**Idiom Press**  
**P.O. Box 1985**  
**Grants Pass,OR 97528**  
www.idiompres.com  
sales@Idiompres.com

Dear Logikit CMOS-4 Keyer owner:

We have found that the PC board for your Logikit CMOS 4 keyer was designed such that the 5-volt voltage regulator draws a steady current of about 1.5 mA from the battery pack at all times, regardless of whether the keyer is in use or not. This will drain the batteries within a few months.

Figure 1

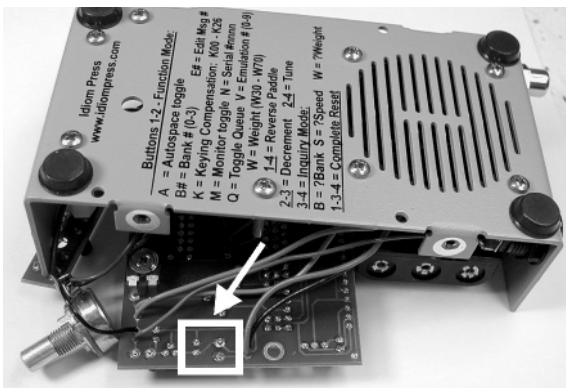
- 7) Turn the keyer over and slide the keyer PC board out slightly from the case (see Figure 1 on the following page).
- 8) Locate the PC board trace which connects the ungrounded side of C2 to the cathode (banded) end of D3 (see Figure 2 on the following page).
- 9) Using a SHARP a sharp knife (an X-acto knife, or single-edged razor blade are preferable) CAREFULLY cut the trace between C2 and the cathode (banded) end of D3 (see Figure 3 on the following page),

Figure 3

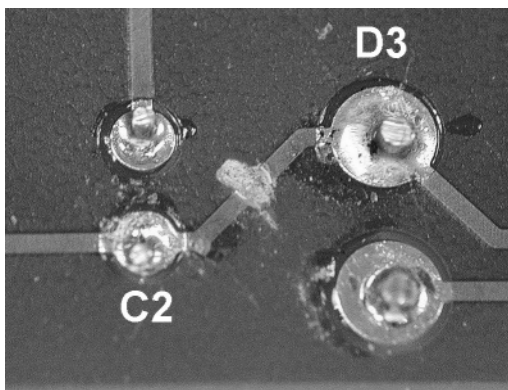
An easy and relatively painless method of cutting this trace is to make two (2) straight down cuts in the trace, about 1/16" (1.6mm) apart, cutting completely through the copper of the trace. Then apply the tip of a (clean) HOT soldering iron to the trace between the two cuts. After about 10 seconds, the trace should lift off much more easily.

Figure 4

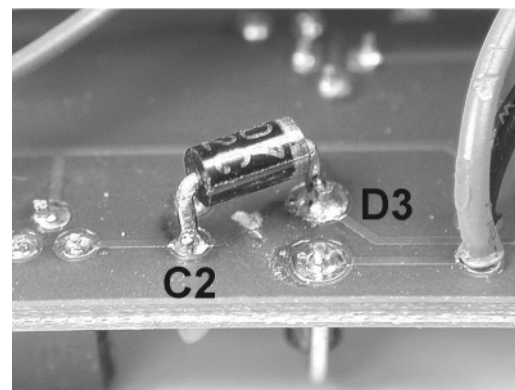
- 10) Regardless of how you cut the trace, use an ohmmeter to verify that the trace is cut (very high resistance).
- 11) Install a 1N400x diode (or any diode of the 1N4001 thru 1N4007 series) across the cut trace as follows:
  - A) Bend the diode leads straight down, right AT the body of the diode.
  - B) Cut the leads so they extend no less than 1/16" (1.6mm), but no more than 1/8" (3.2mm), past the bottom of the diode body (see Figure 4).
  - C) Lightly tin each lead with solder.
  - D) If required, apply a small amount of additional solder to the soldered joint at C2 (only) where the diode will be installed. DO NOT apply additional solder to the connection at D3 yet.
  - E) Referring to figure 4, place the diode with its cathode (banded) end on the solder pad for D3 and its anode (UNbanded) end on the solder pad for C2. HOLD the

diode in position and briefly touch the tip of your soldering iron to the pad at C2, melting the solder and securing one end of the diode at that point.

- F) In a similar manner, secure the other end of the diode to the solder pad at D3. Note that you may have to add a small amount of solder to this joint in order to properly attach the new diode.
- G) After both ends of the new diode are soldered into place, it is a good idea to go back quickly and reheat both joints, one at a time, to ensure a good connection.
